# Transalloys coal-fired power station, near eMalahleni, Mpumalanga Province

Motivation for amendment of the Integrated Environmental Authorisation

DEA Ref.: 14/12/16/3/3/97

June 2019

**Figure 2:** The proposed amendment layout for the power plant and ash dump with Environmental Sensitivities (2019)

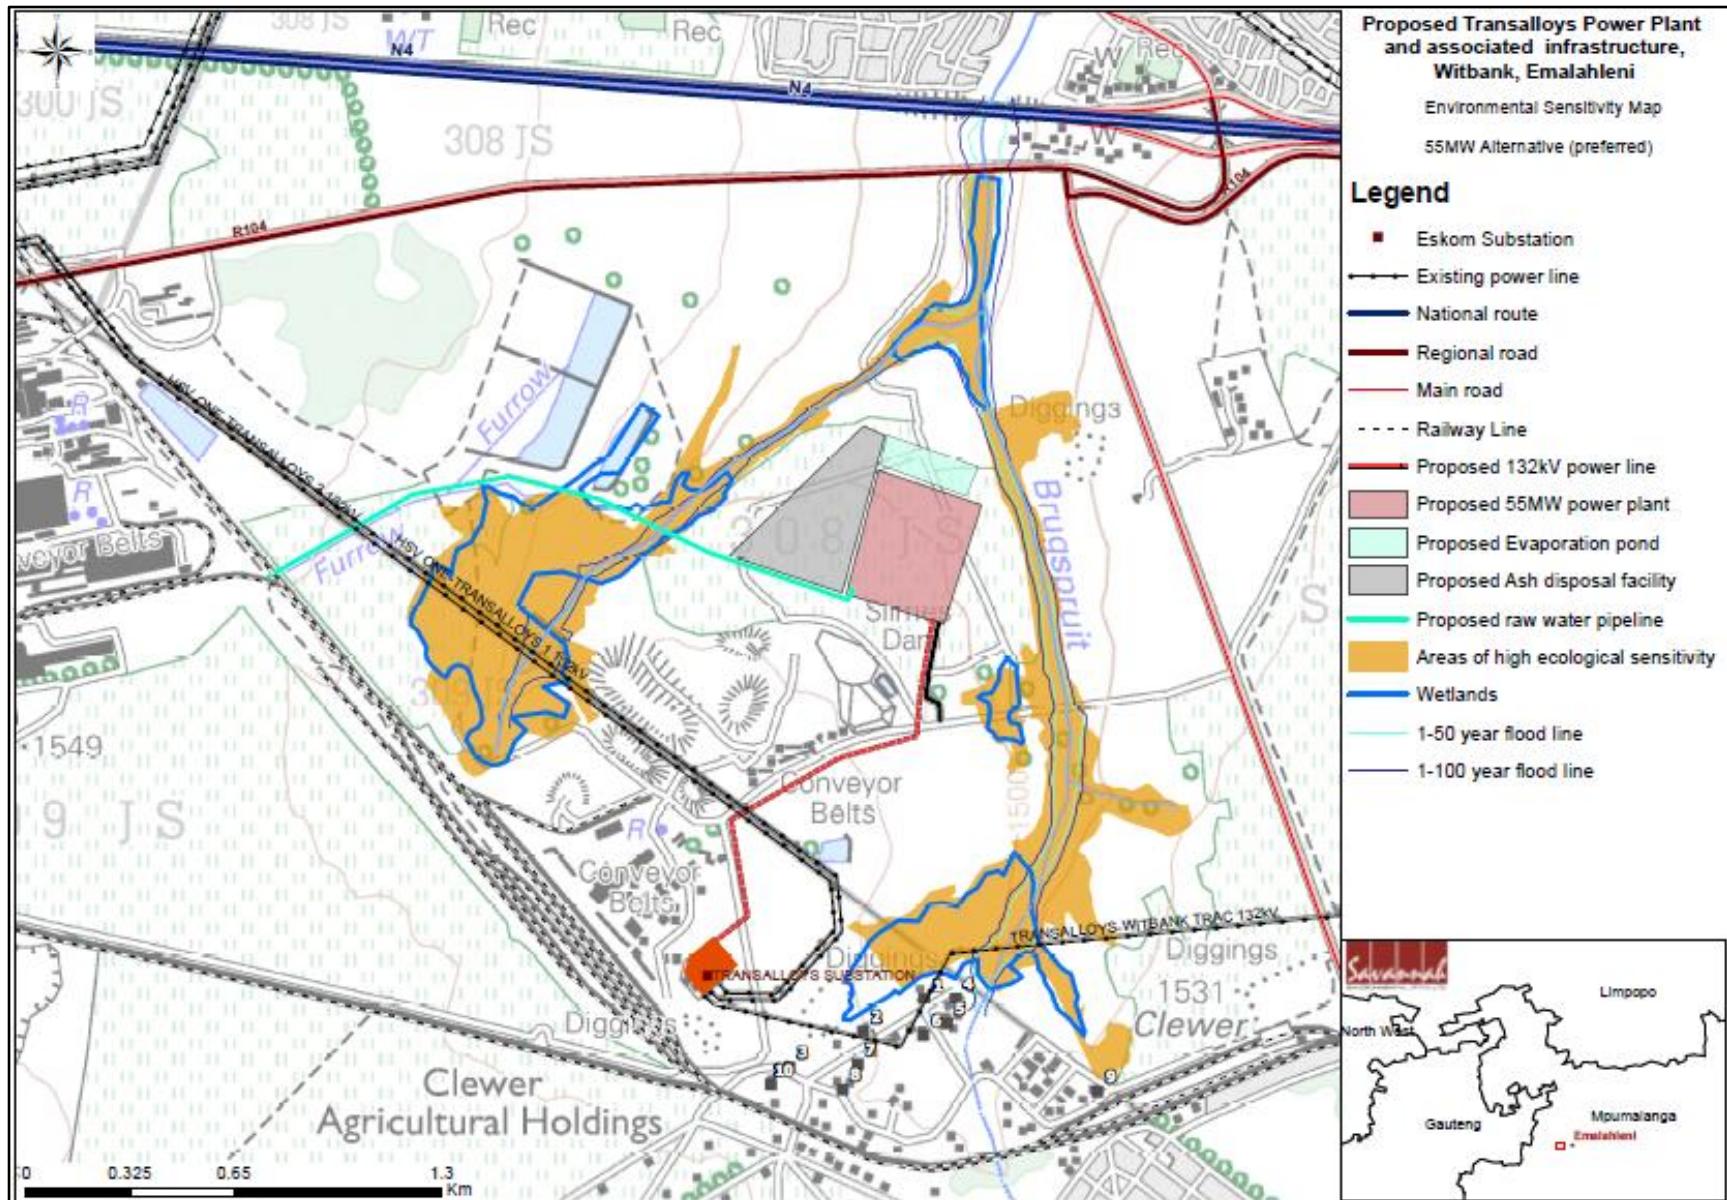
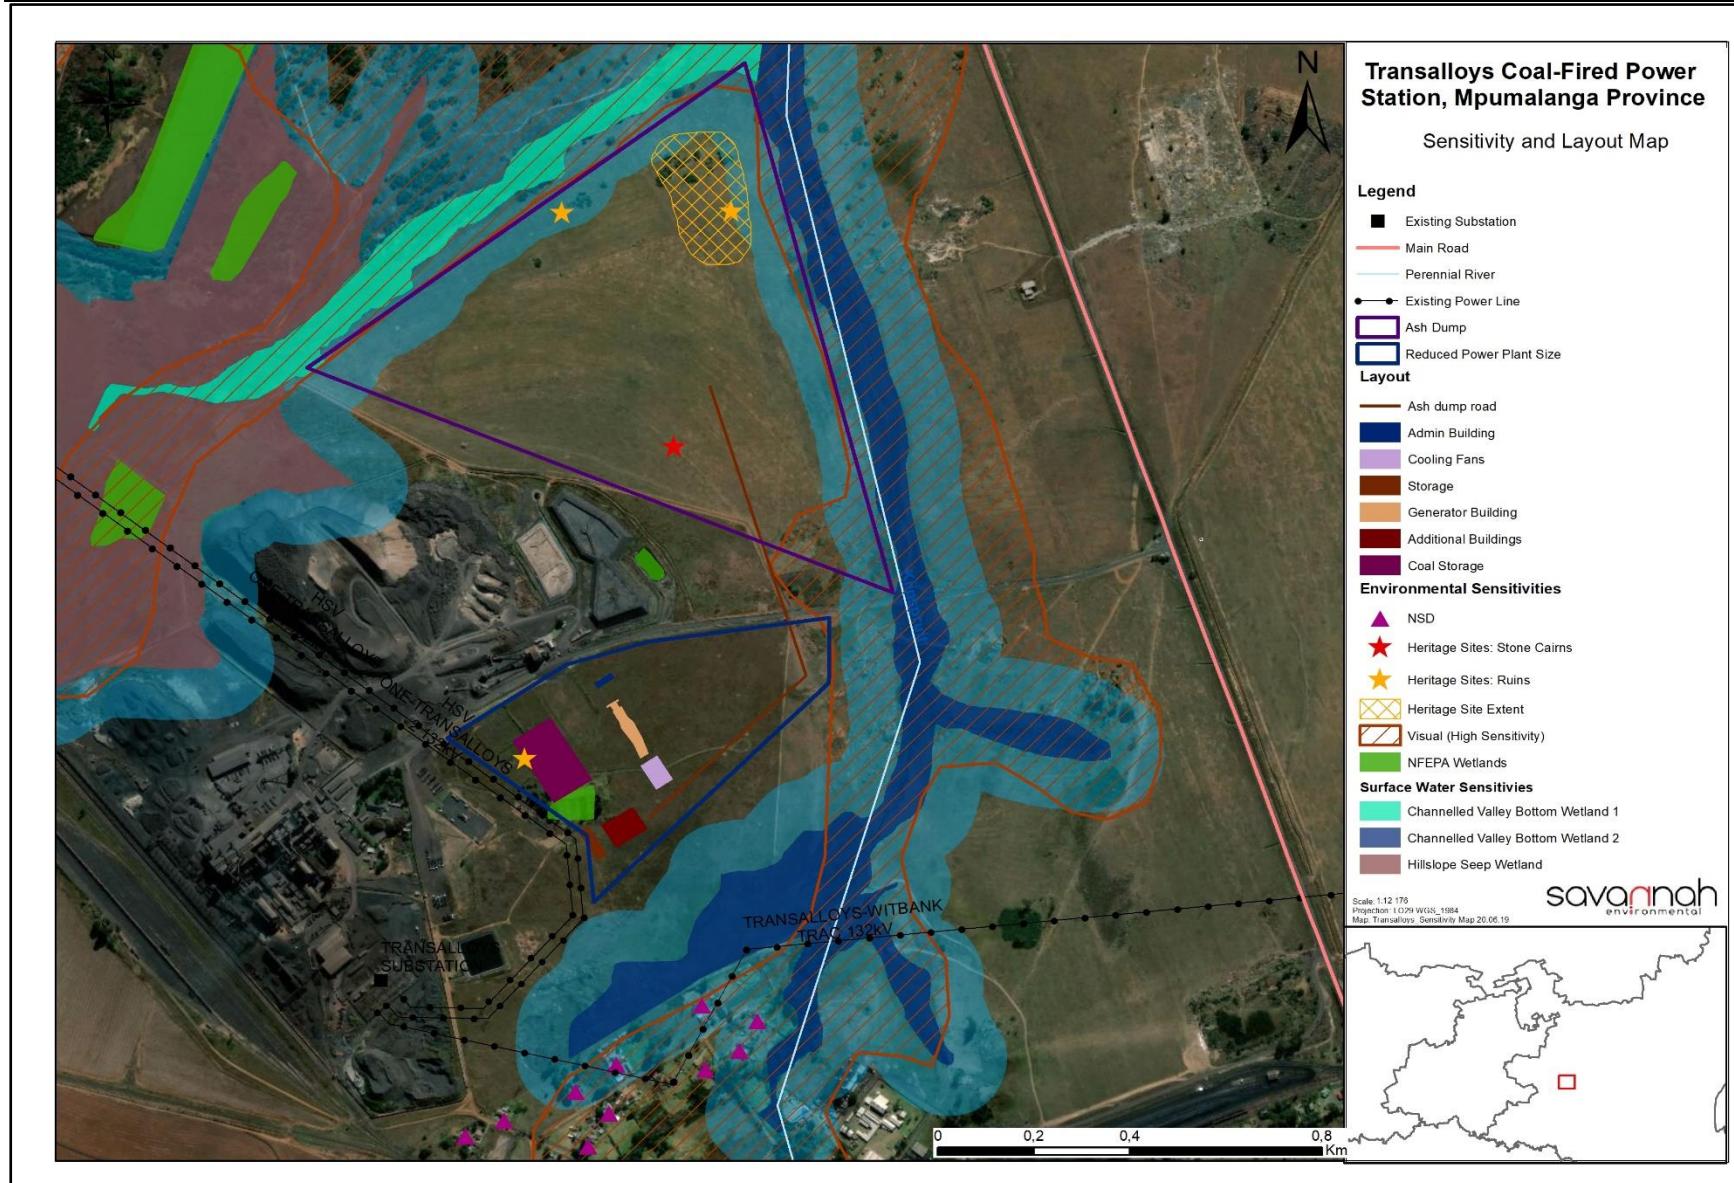
The approved layout contained within the original integrated EA, issued 2 March 2016, and "Page xiii: Figure 2: Environmental Sensitivity Map overlay of 55MW power plant alternative (preferred)" of the final EIR (dated 28 May 2015) - Alternative 1, is proposed to be amended for technical reasons, in particular by the swapping of the locations for the power plant and the ash dump (as contained in the final EIR).

In order to maximise the power output of the plant, layout adjustments are required. A pipeline passing through the site initially allocated for the Ash disposal facility was identified during detailed land audits, rendering the size of the site insufficient for the ash disposal facility, but large enough for the power plant facility. This necessitated exchanging the power station zone and the ash dam disposal zone (literally exchanging the location of the one for the other) as approved with Alternative 1 in the original integrated EA, issued 2 March 2016. The need for amending the layout also allowed for minor optimisations of the facility, which was applied to the layout provided for approval in this amendment application.

Table 2 indicates that the extent of the power plant is slightly reduced compared to the 150 MW power station previously assessed. The ash disposal site has increased by 15 ha as compared to the 150 MW previously assessed layout. The change in the extent of the footprints for the power plant and the ash disposal site is attributed to the swap in locations.

**"3.1 Authorisation is granted for the establishment of Transalloys coal-fired power plant and associated infrastructure within site co-ordinates as indicated above. The updated layout (DWG.NO F0315K-Z-01) as supplied for in the Amendment Application is hereby approved."**

Figure 3: Updated power plant layout (A3 Map included in [Appendix H](#)).

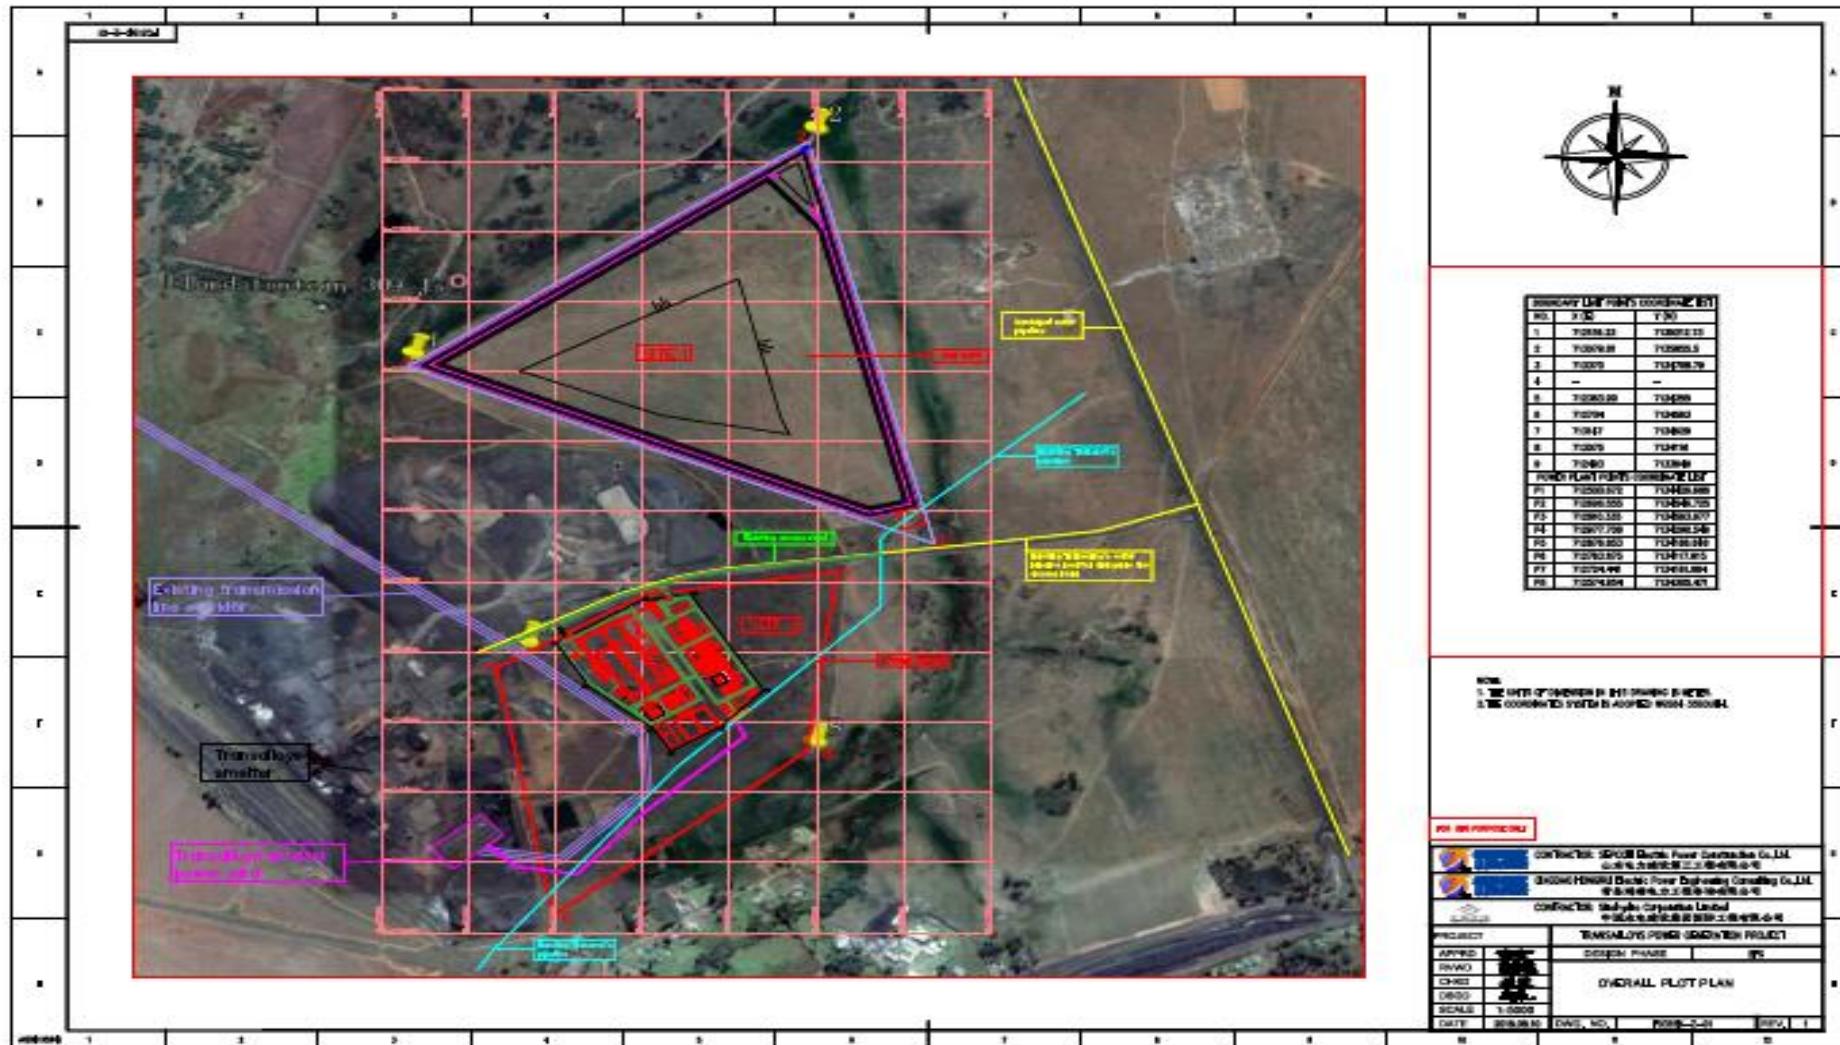
The table below provides a detailed comparison of the project description included in the EA as authorised on 02 March 2016, with the proposed project components which are requested to be amended (shown in **bold** text) This proposed amended layout is presented in Figure 2.
